# JONES & BEACH ENGINEERS INC.

**RE: Response Letter 2  
19 Old Gonic Road, Rochester, NH  
Tax Map 131, Lot 1  
JBE Project No. 21090**

We are in receipt of comments from Theresa Hervey, Town Assessing Department, Ryan O'Connor, Conservation Commission, and Dana Webber, Department of Public Works dated September 27, 2022. Review comments are listed below with our responses in bold.

# PROPOSED SITE PLAN "BAYBERRY COMMONS"

DRAWING No.  
**OFF4**  
 SHEET 36 OF 48  
 JBE PROJECT NO. 21090

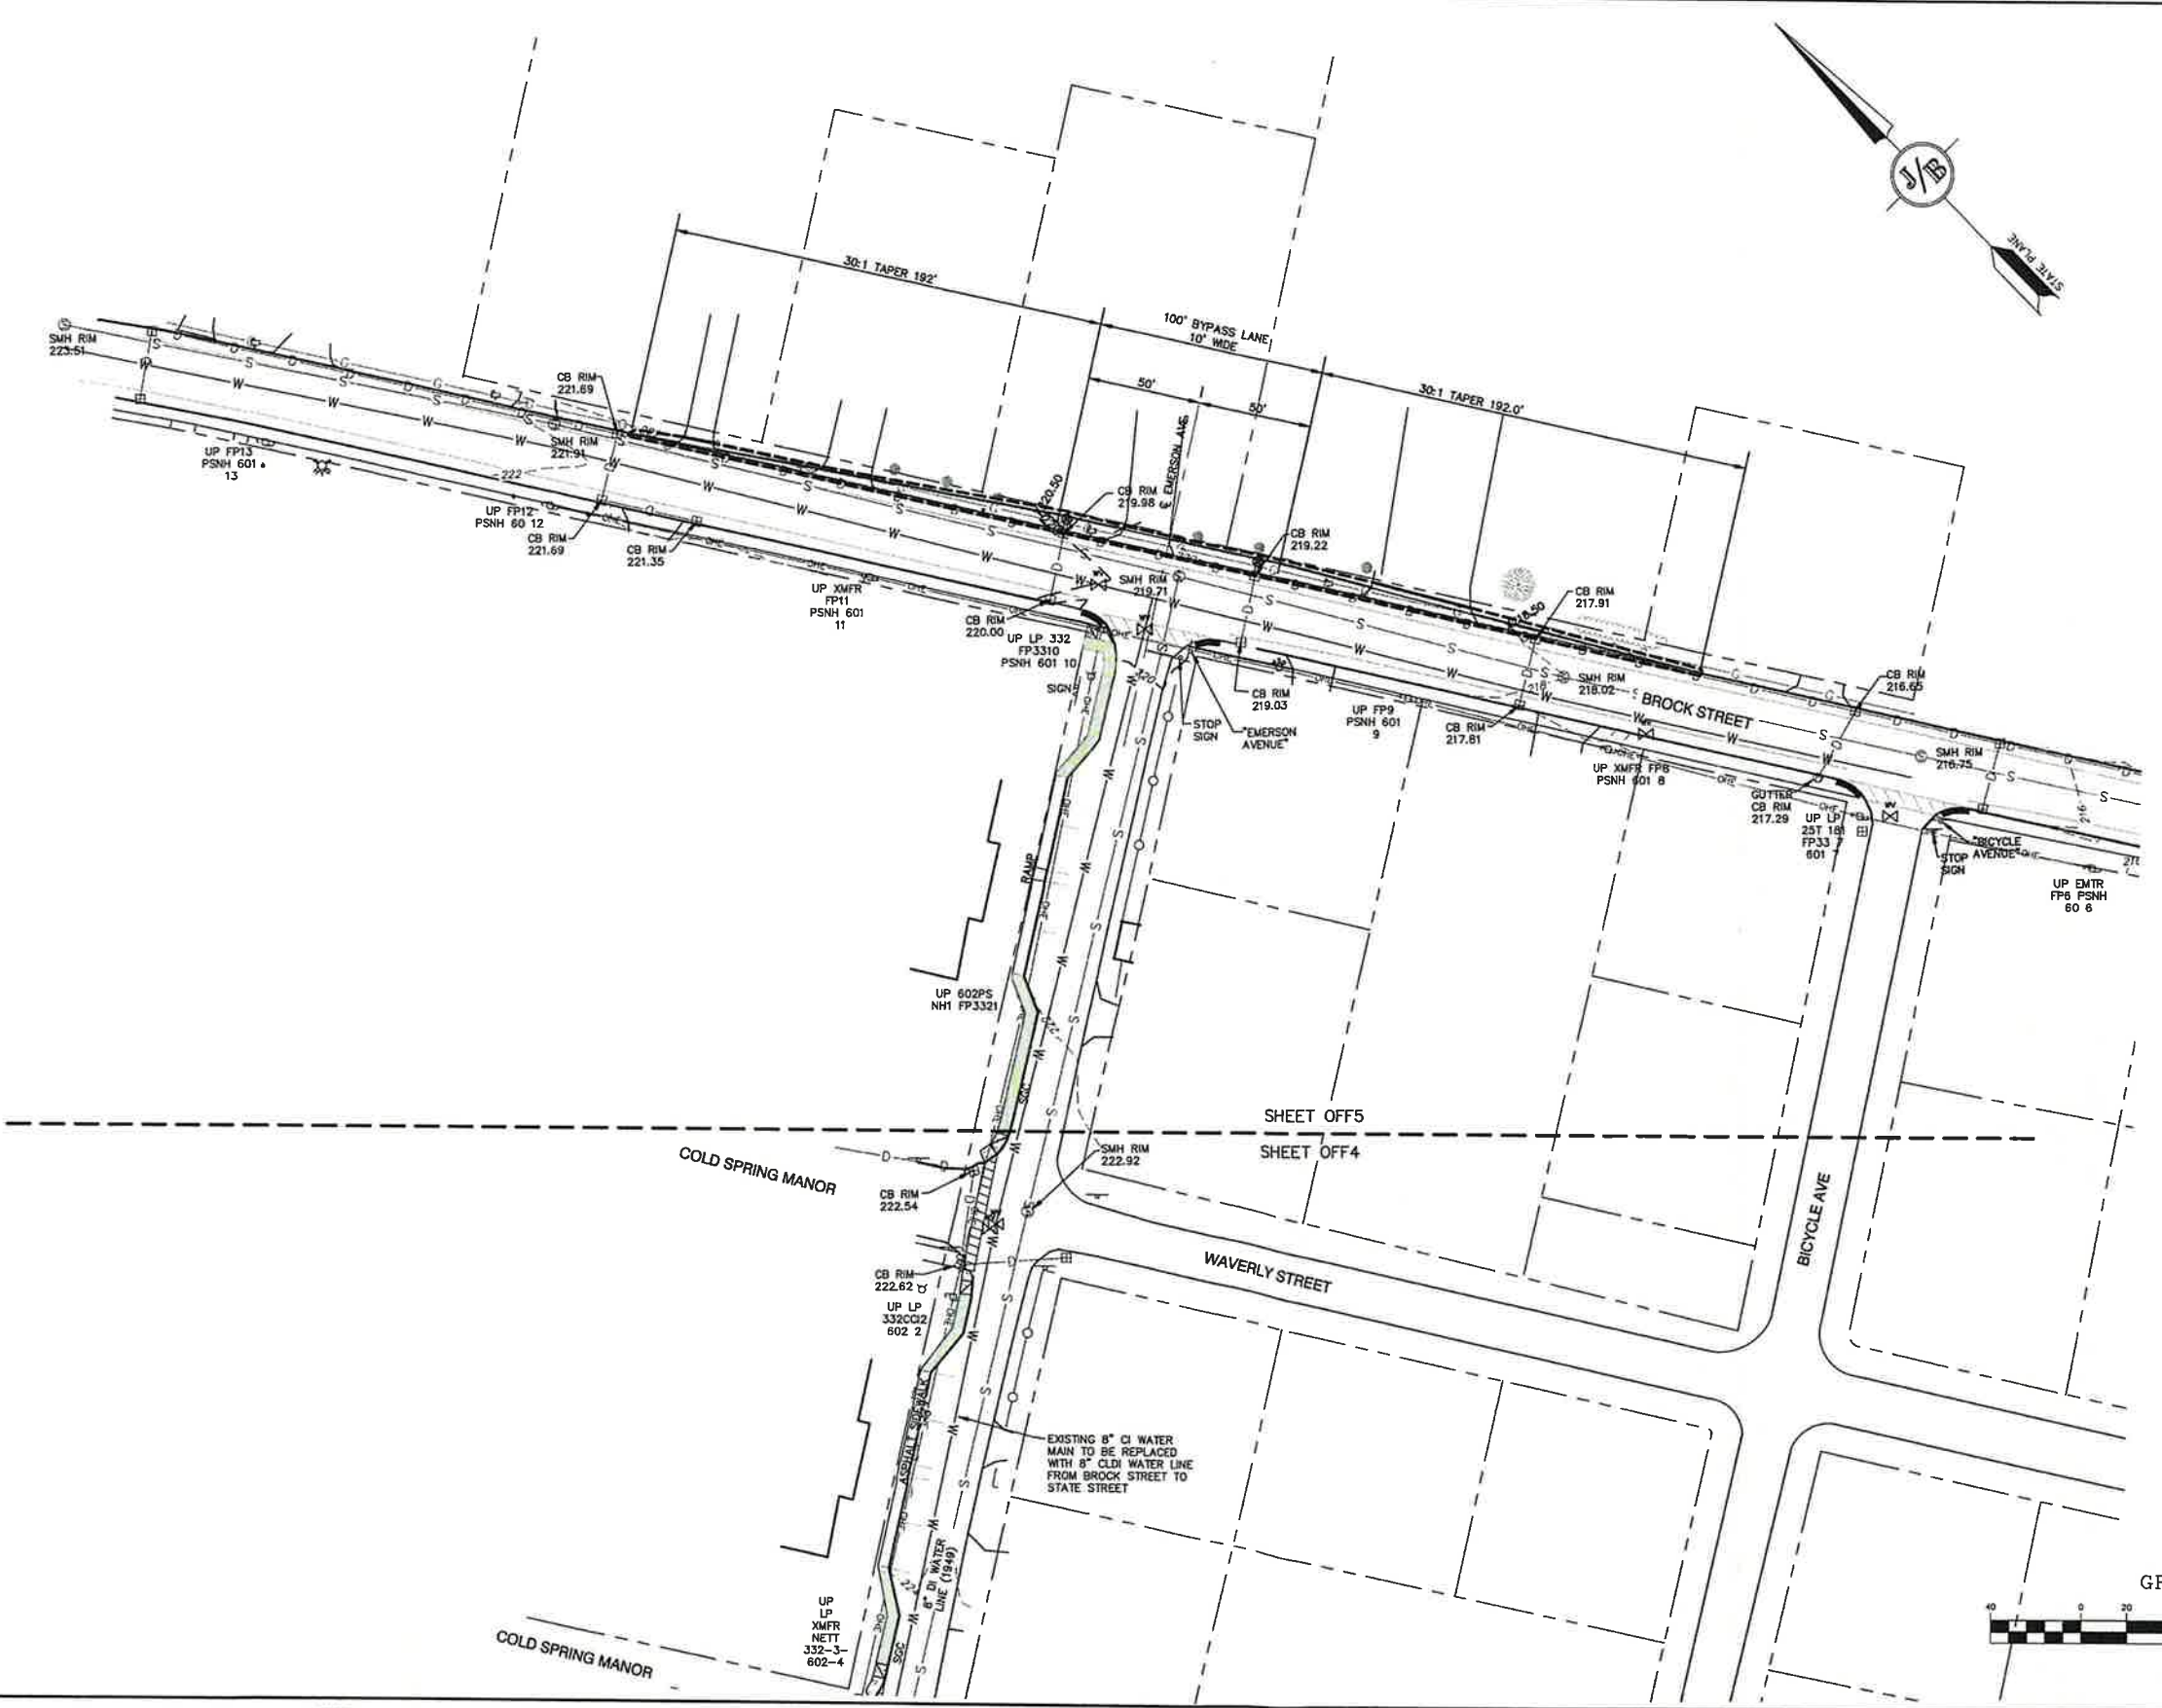
**RESPONSE: A note referencing Sheet C4 has been added to show the continuation of existing conditions in the offsite improvement area.**
- k. Sheet OFF4, the existing DMH near Emerson Court is shown covered by new sidewalk. Relocate the DMH or sidewalk. Please review all drainage, grading and conflicts in the City ROW for the offsite improvements.

**RESPONSE: The sidewalk has been relocated on Sheet OFF4 and drainage, grading and conflicts with City ROW have been addressed.**
- 8. Recently adopted water and sewer connection fees will be assessed at the time of water/sewer connection permit application for each building. Prior to CO for each building, the fees must be paid.

SEWER CONNECTION TO EXISTING STRUCTURE

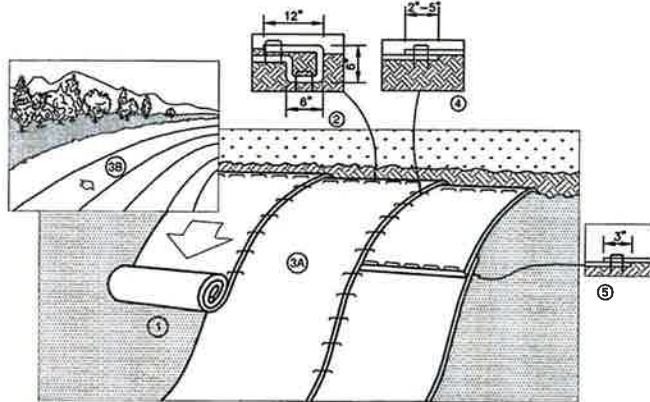
- c. Sheet P6 shows profile of connection to existing sewer manhole, provide a detail of the connection to the existing including repair/patching/waterproofing of new penetration.

**RESPONSE:** A detail of the connection to the existing sewer manhole has been added to Sheet D5.
